**RE:** Petition No. 1030  
Request to Outright Vacate a Portion of Dunkirk Ave. in the Area Bound by  
Dumfries, Sanders, Greyfriars Ave. and Wabash R.R.

**NOTICE OF PROPOSED CHANGE IN PROPERTY**

REQUEST TO CONVERT TO EASEMENT  
 A PORTION OF DUNKIRK AVE., 60 FT. WD.  
 REQUEST TO OUTRIGHT VACATE A PORTION OF  
 DUNKIRK AVE., 60 FT. WD.  
 IN THE AREA BOUND BY  
 DUMFRIES, SANDERS, GREYFRIARS AVE.  
 AND WABASH R.R.

**Detroit Water & Sewerage Department**  
**Provisions for Relocation Due to Vacation for Petition No 1030**

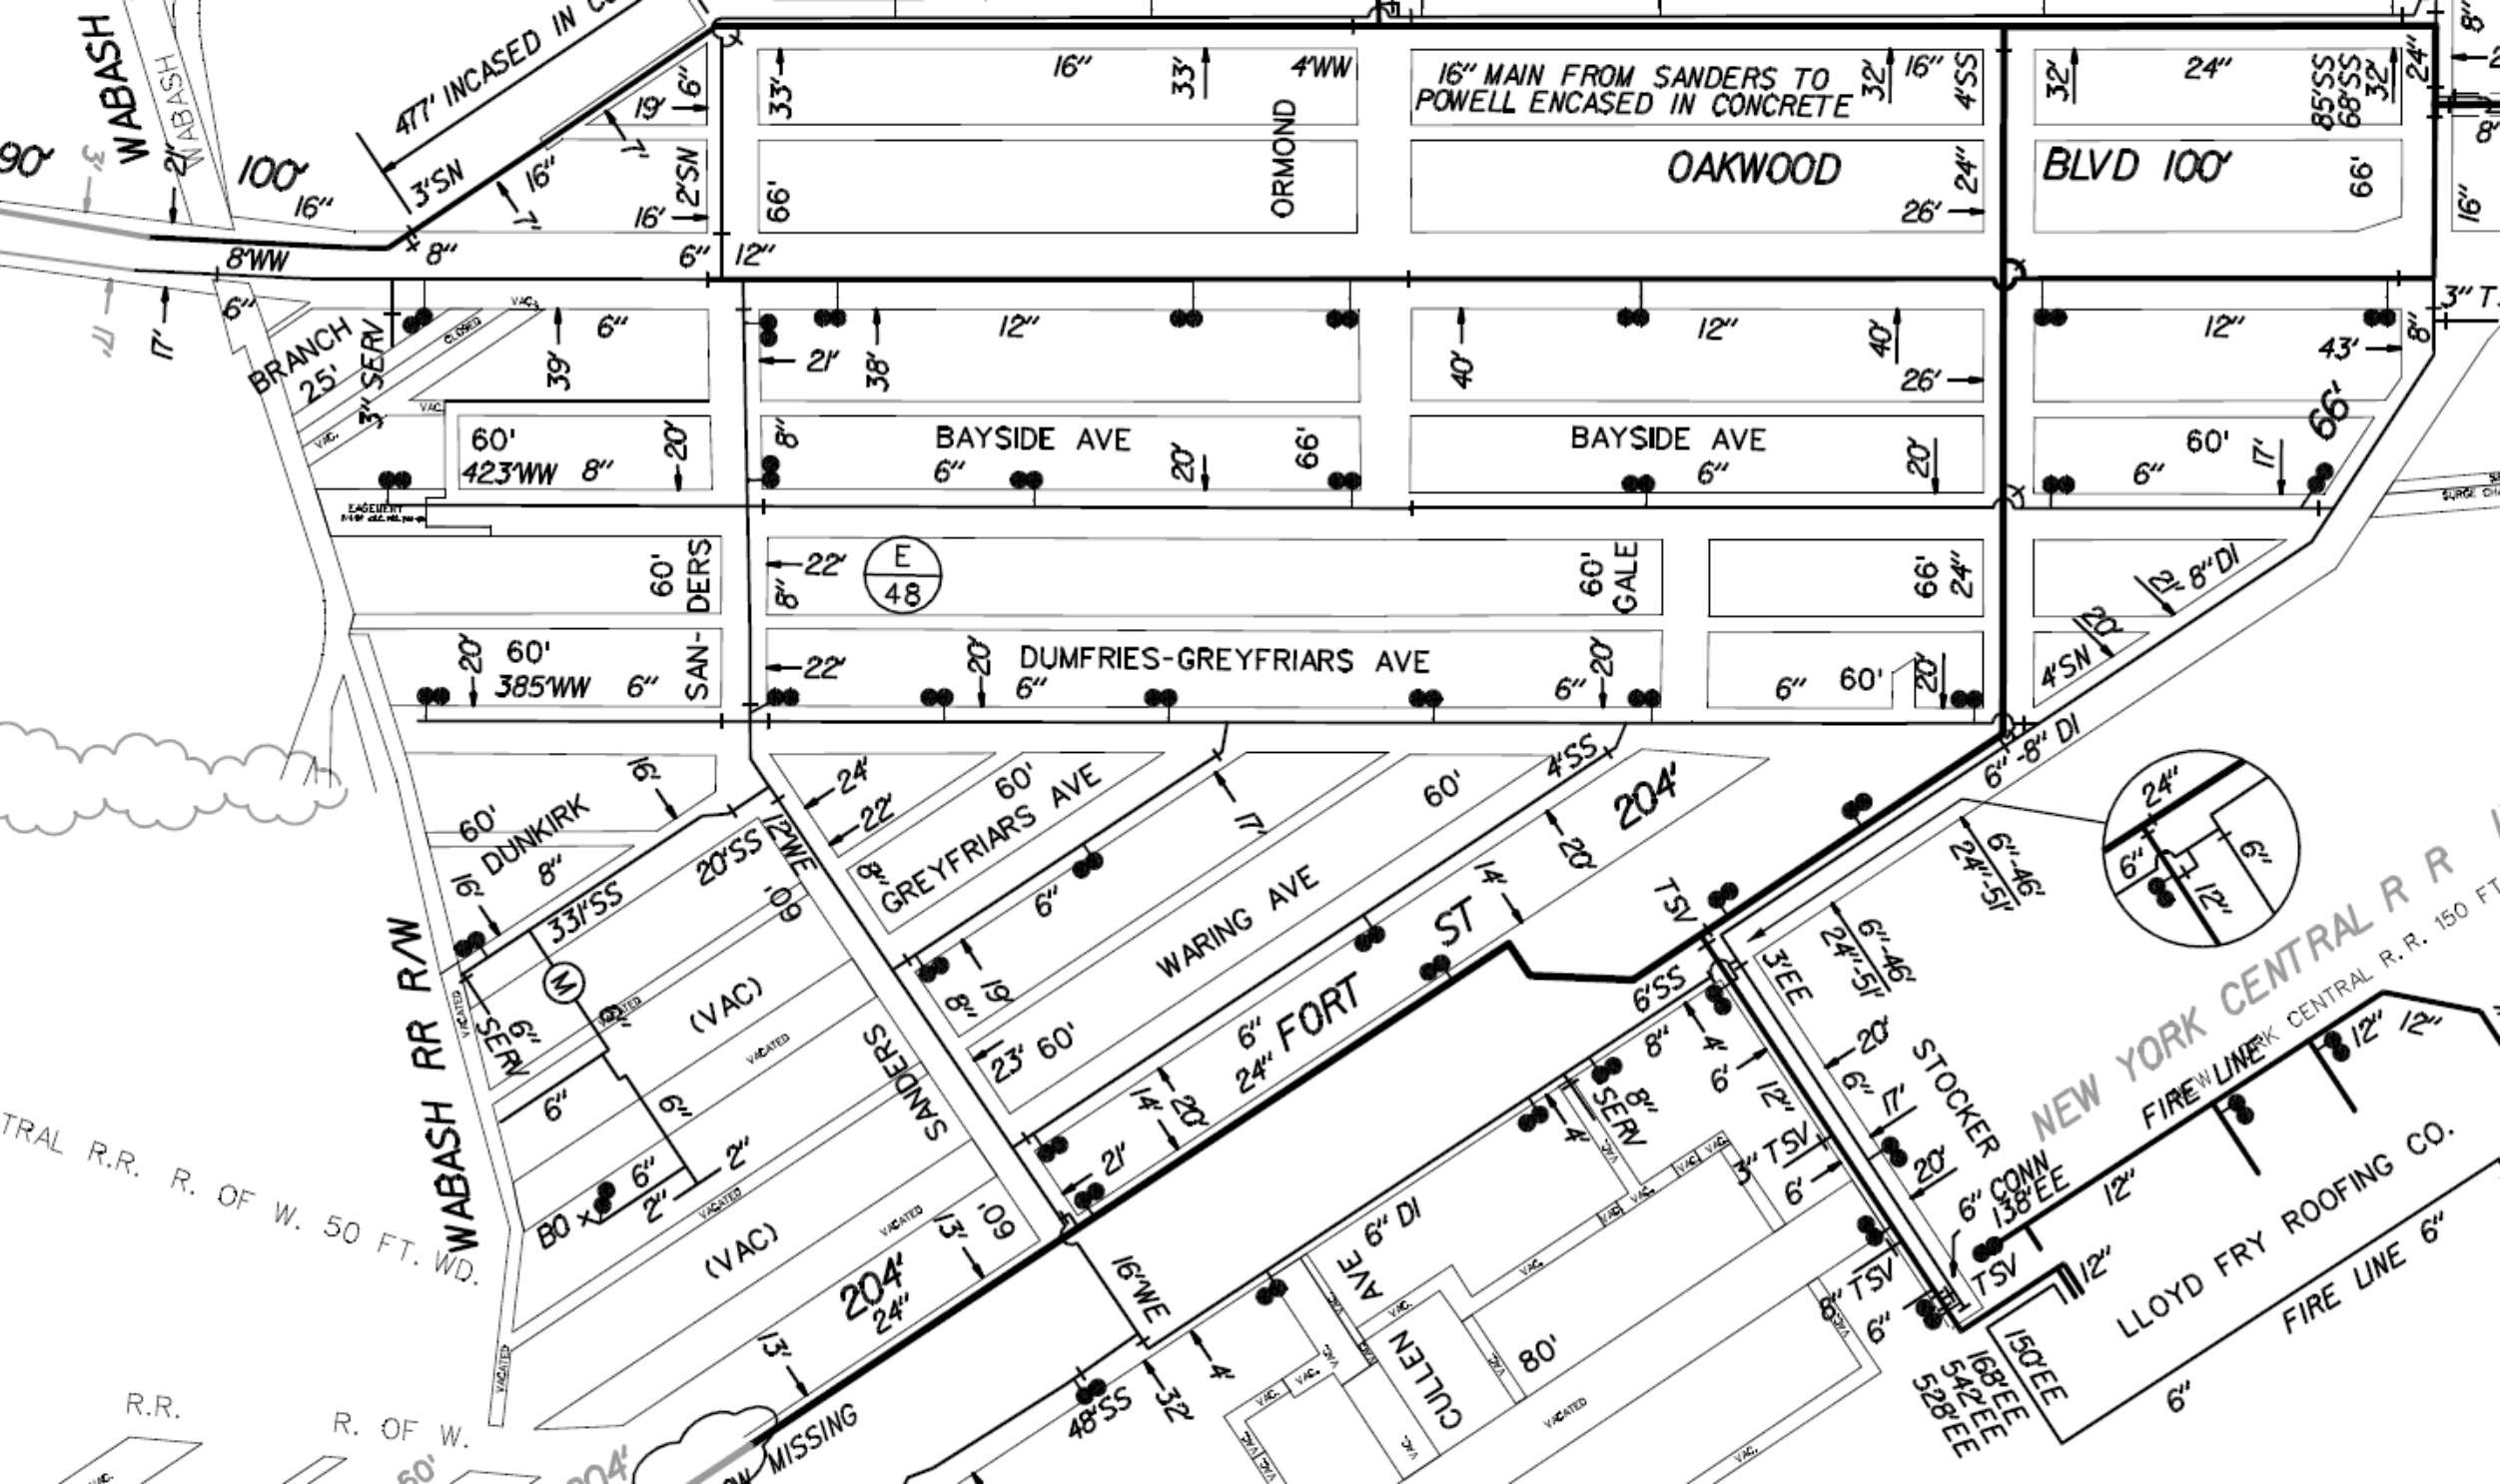
Provided that the petitioner shall design and construct proposed sewers and to make the connections to the existing public sewers as required by the Detroit Water and Sewerage Department (DWSD) prior to construction of the proposed sewers,

Provided that the plans for the sewers shall be prepared by a registered engineer; and further

Provided that the petitioner shall grant to the City a satisfactory easement for the sewers; and further

Provided that upon satisfactory completion, the sewers shall become City property and become part of the City system. And any existing sewers that were abandoned shall belong to the petitioner and will no longer be the responsibility of the City.
